Sincere thanks for the evaluation of this work and your valuable comments and suggestions for improving this manuscript. We carefully considered the concerning points and made efforts to improve the rigor, logic, and clarity of our manuscript titled “**A comprehensive geospatial database of nearly 100,000 reservoirs in China**”. Here we submit the revised version, which has been modified according to the comments from the editor and reviewers. According to the editor and reviewers’ comments/suggestions, we clarified the manuscript and response letter below regarding the appropriate paragraphs and sections. The major changes that we made in the revised manuscript are summarized as follows:

COMMENTS FROM EDITORS AND REVIEWERS:

Figure 4. The distribution of all sampled validation reservoirs.

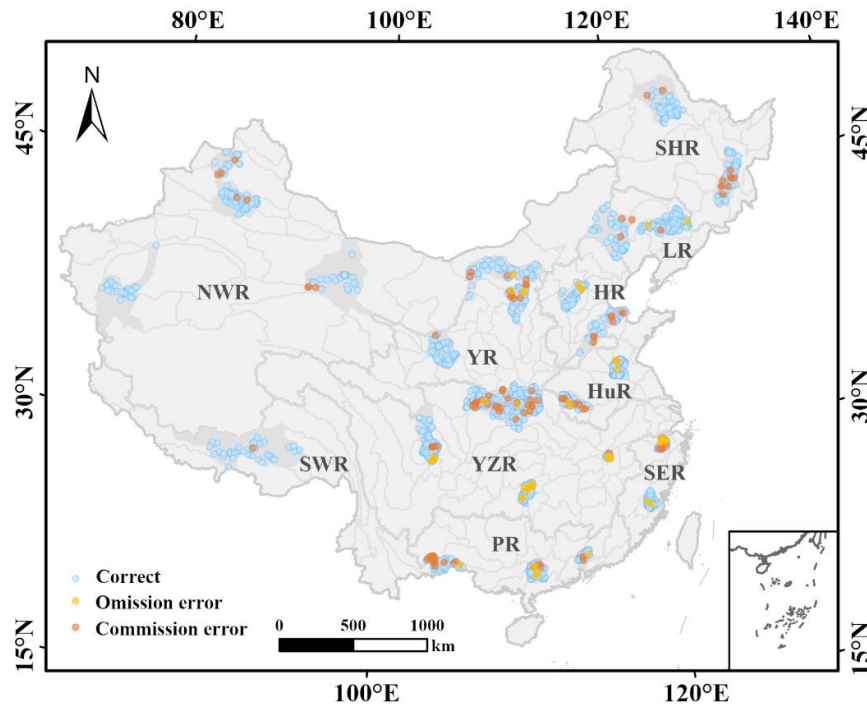
1. I have concerns on the accuracy evaluation of their data (section 4.2). Line 338: does the random selection process is manual? In this section, I can not understand what accuracy means here. Do you mean area? Please provide more detail.

Response: Thanks for pointing out the unclear information. We corrected the statements by specifying that the random selection process is based on the Create Random Sampling Points tool from the ArcGIS Pro Data Management menu. Accuracy of the CRD database in Section 4.2 refers to the evaluation of the commission and omission errors of the database itself. Here, the commission error represents geocoding errors where the CRD information is inconsistent with the validation reference, and the omission error indicates the number of missing reservoirs in the samples.

To further illustrate the accuracy of the CRD database, we followed the same sampling scheme and randomly selected ten validation sub-basins from the remaining sub-basins, including 1,752 reservoirs. The distribution of all sampled validation reservoirs is shown in Figure 4. Consistent with the first validation result, the evaluation accuracy of all river basins is higher than 90%. The accuracy ranges for the CRD database from 90.70% to 97.64% among different basins, with an overall accuracy of 93.61%. Integrating the two validation results, our overall evaluation accuracy is 95.13% in terms of commission and omission errors (Table 3).

Additionally, we clarified the method for selecting sub-basins, updated Table 3, and added Figure 4 in the revised manuscript to address the referee’s concern. **(Line 366-369)**

“To evaluate the commission and omission accuracy of the CRD database, we randomly selected sub-basin areas in each first-level river basin across China and manually checked 3,634 reservoirs (Figure 4). The collection of the validation sub-basins followed the Create Random Sampling Points method.”

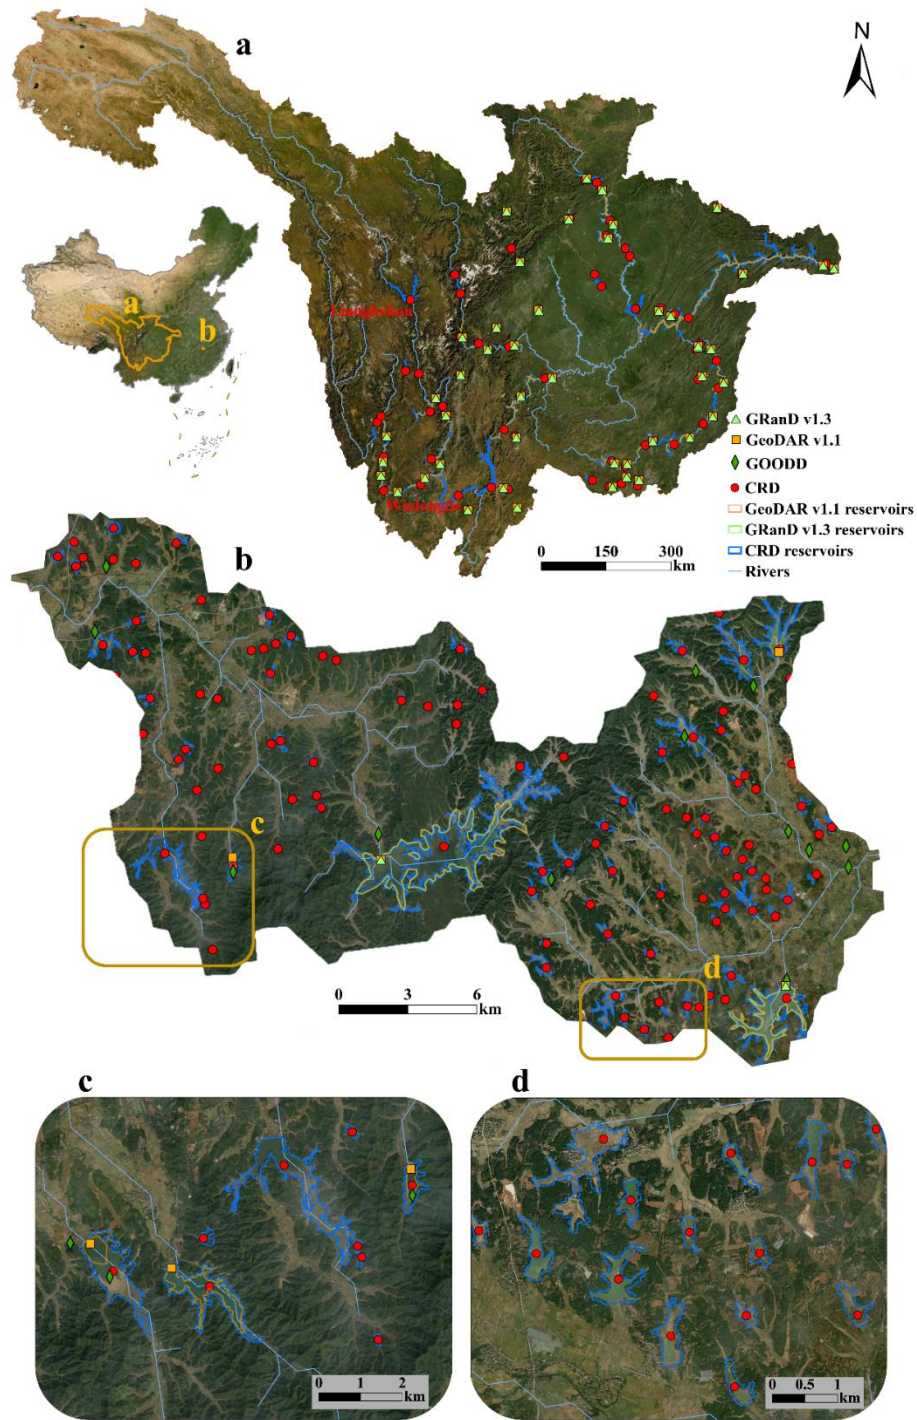
2. For dataset comparison, you can not say improvements just based on more count, area, and storage. Does this data have better accuracy over other ones? Please try to show that. Overall the accuracy assessment is not clear, which directs an unclear description of their contribution.

Response: We agree with the reviewer. The main purpose of CRD database is to catalogue more complete spatial distribution of reservoirs in China, especially to supplement median and small-sized reservoirs. Therefore, we cannot say that it has improvements over those global reservoir products. To clarify this point, we changed the relevant statement. Following this suggestion, we also added Figure 10 and one paragraph in the ‘Comparisons with other reservoir databases’ section to state the supplements of the CRD database. **(Line 481-501)**

Figure 10a shows the distribution of large reservoirs (storage capacity larger than 3 million m³) in the upper reaches of the Yangtze River in GRanD v1.3, GeoDAR v1.2, and CRD. Because the GOODD dataset is limited by the basic property (reservoir storage capacity, dam height), it was not included in comparing large reservoirs. GeoDAR v1.2 incorporates GRanD v1.3 so that the pattern of large reservoirs in the upper Yangtze River is consistent between the two databases. Compared with GRanD v1.3 and GeoDAR v1.2, CRD has added 16 large reservoirs in the upper reaches of the Yangtze River, with a total storage capacity of 52.60 km³, of which the total storage capacity of new reservoirs in the past five years accounted for 77.00% (40.50 km³). The large reservoirs dominate the total storage capacity in the basin. Therefore, the increase of new large reservoirs dammed in recent years is one of the major differences of CRD in storage capacity.

Another supplement of CRD is to amplify the local details of smaller reservoirs based on enlarging the total area and storage capacity. Figure 10b shows the reservoir distribution in the 10-level sub-

basin of Poyang Lake, and Figure 10c-d contains the enlarged details in Figure 10b. GRanD v1.3, GeoDAR v1.2, GOODD, and CRD can all digitize reservoirs on rivers with catchments of more than 10 km² (Figure 10b-c). However, many smaller reservoirs were not digitized by GRanD v1.3, GeoDAR v1.2, and GOODD. Overall, CRD is relatively better mapping reservoirs at smaller watershed levels (Figure 10d).

“Figure 10a shows the distribution of large reservoirs (storage capacity larger than 3 million m³) in the upper reaches of the Yangtze River in GRanD v1.3, GeoDAR v1.2, and CRD. Because the GOODD dataset is limited by the basic property (reservoir storage capacity, dam height), it was not included in this comparison. GeoDAR v1.2 incorporates GRanD v1.3 so that the pattern of large reservoirs in the upper Yangtze River is generally comparable between the two databases. Compared with GRanD v1.3 and GeoDAR v1.2, CRD has added 16 large reservoirs in the upper reaches of the Yangtze River, with a total storage capacity of 52.60 km³, of which the total storage capacity of new reservoirs constructed in the past five years accounted for 77.00% (40.50 km³). The large reservoirs dominate the total storage capacity in the basin. Therefore, the increase of new large reservoirs dammed in recent years is one of the major differences of CRD in storage capacity. As shown in Figure 10b-c, GRanD v1.3, GeoDAR v1.2, GOODD, and CRD can all digitize reservoirs on rivers with catchments of more than 10 km². However, many smaller reservoirs were not compiled in GRanD v1.3, GeoDAR v1.2, and GOODD.”
